# *Landscape Rationale*

## Proposed Go Ahead Bus Depot, Lower Ballymount Road, Dublin 12

## *Please see Response to Additional Information Request - SD21A/0213*

# Landscape Masterplan

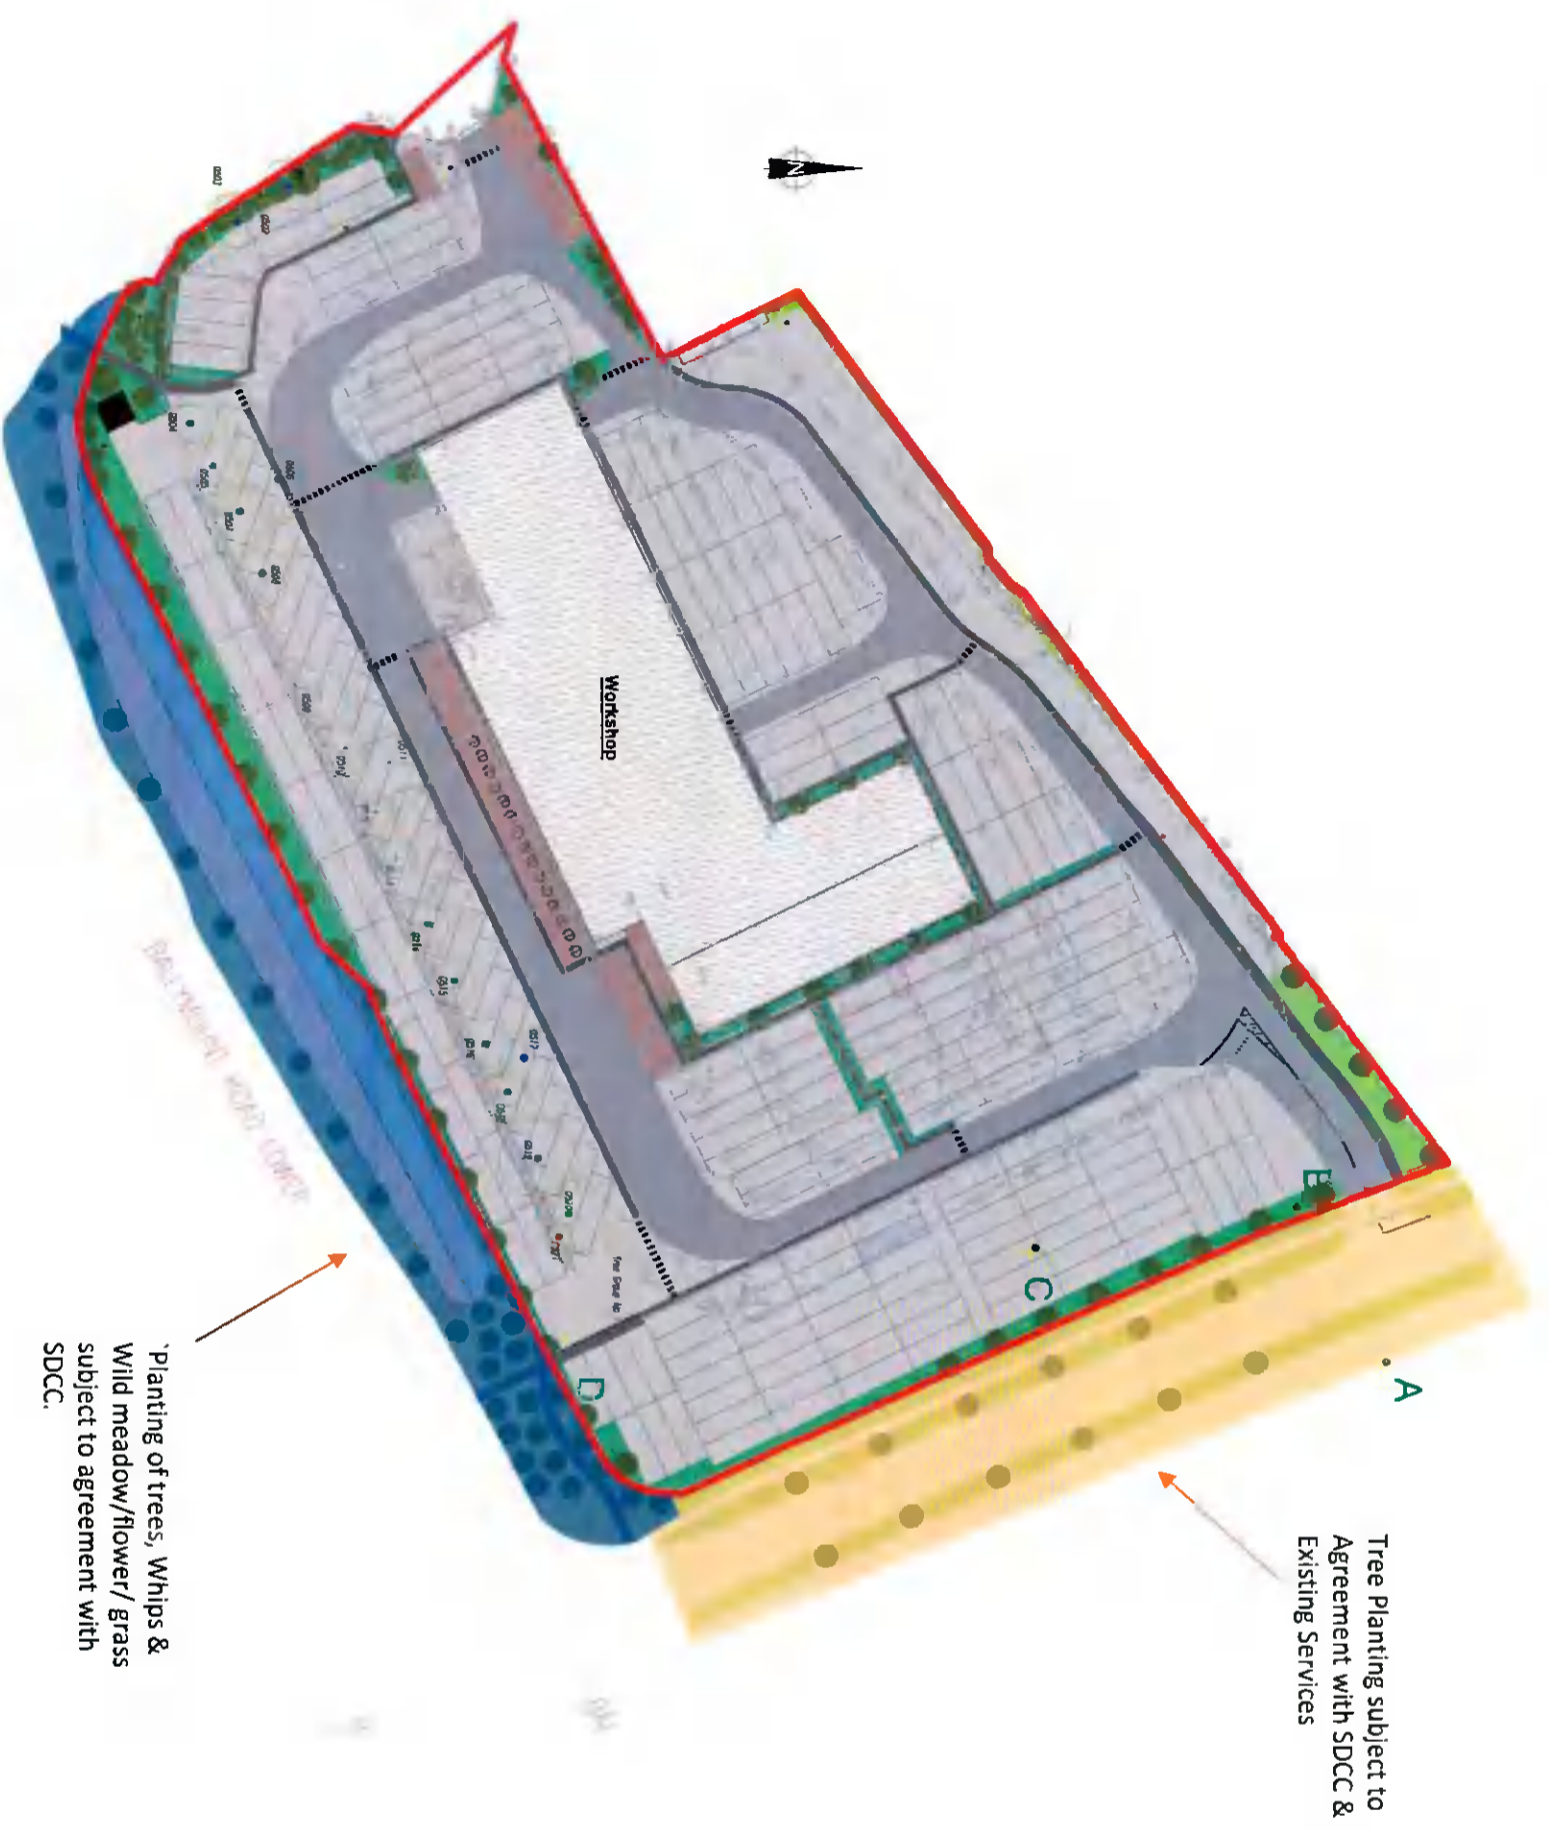
*3. The planting of more trees especially in the urban environment is considered one of the key strategies in mitigating the impacts of climate change. Trees sequester carbon and store it during its photosynthesis process. In addition, trees can also:*

- *Prevent flooding*
- *Reduce city temperature*
- *Reduce pollution*
- *Keep soils nutrient-rich* *The applicant is requested to provided information on additional tree planting as part of the landscape proposals.*

*The applicant is requested to provided information on additional tree planting as part of the landscape proposals*

**Response:** The proposed development shall be screened by a native hedge and native trees. The rootzone for these native plants has been increased with a further structural soil proposed to

It is proposed to plant, at the client expense, the grass margins to the East with semi mature 18 – 20cm trees or similar subject to agreement with the Local Authority (SDCC)

It is furthermore proposed to plant the open space area to the south of the proposed development by the planting of trees, whips and wild meadow/flower mix to aid in biodiversity, carbon sequestration, prevention of flooding, reduction in city temperature. They shall also help reduce pollution by removing particulate matter from the atmosphere.

Please see Drawing 01 for the plan of the proposals and the rationale for the type of trees.
